Advice to Shoalhaven City Council

Development Application RA 11/1003

11-17 Fegan St Huskisson

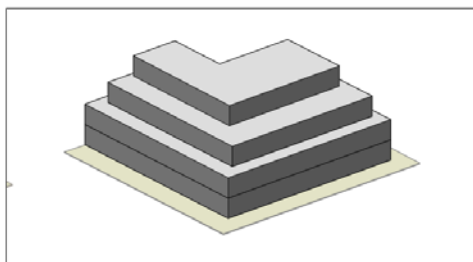
- The development proposes a ‘design frontage’ to Kent Lane. The draft DCP has a deliberate aim for Kent Lane to be primarily a service lane with waste facilities and parking areas facing the lane. The level of amenity for apartments within the subject development which exclusively overlook the lane may be adversely affected by future developments which may choose design outcomes that use Kent Lane as it was intended – i.e. service lane.

- The area provided for deep soil planting is effectively the ‘left-over’ spaces comprising the boundary setbacks. This does not assist in achieving a landscape character that is dominant over the building form.

- The one-way driveway is likely to lead to some users of spaces closest to the entry point finding it easier to exit the site via the entry driveway, rather than following the basement design path, which could lead to dangerous traffic conflicts.

- The slope on the entry driveway begins at the kerb line resulting in a change of grade for pedestrians using the verge. This could be present a trip hazard for pedestrians and is not a good design outcome.

- The central courtyard is located entirely over the basement car park, as such will comprise hard surface paving and small ‘garden boxes’ for soft landscaping with no scope of large scale, deep-rooted vegetation. The overlooking of this courtyard by all 46 units further reduces its amenity. As such it is likely that this space will be little more than a “light well” for units with habitable rooms facing the courtyard.

- The balconies on some of the upper floor units seem to be partly enclosed. These areas should be considered as floor area of the units rather than a terrace area forming an extension of the unit. As such, this would constitute an increase in GFA and, hence, FSR.

Extract from Ruker Urban Design Strategy

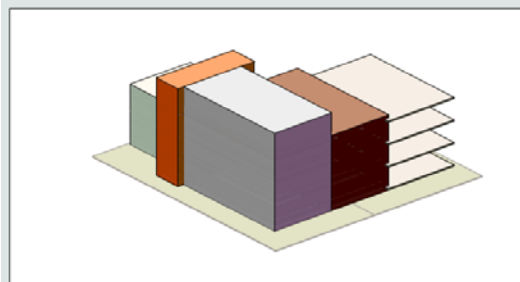
- The proposal would result in a substantial structure with a dominant horizontal form along Fegan Street, which is inconsistent with the desired future character of the area which aims to achieve extensive modelling by designing buildings as a series of three dimensional interconnected and interlocking forms to break up the scale of the building

Undesirable building form

A building designed as a series of horizontal and identical plates (even if stepped) does not employ width and depth nor solid and void. This style of building generally uses its concrete structural frame as the buildings articulation which results in the appearance of a commercial style building without sufficient detailing resulting in a building that is unsympathetic to a residential area and a coastal town character.

Desirable building form

The concept of designing a building in three dimensions; as a series of interconnected and interlocking forms, is a key strategy in creating quality medium density coastal buildings and results in more human and domestic scale multi dwelling buildings.
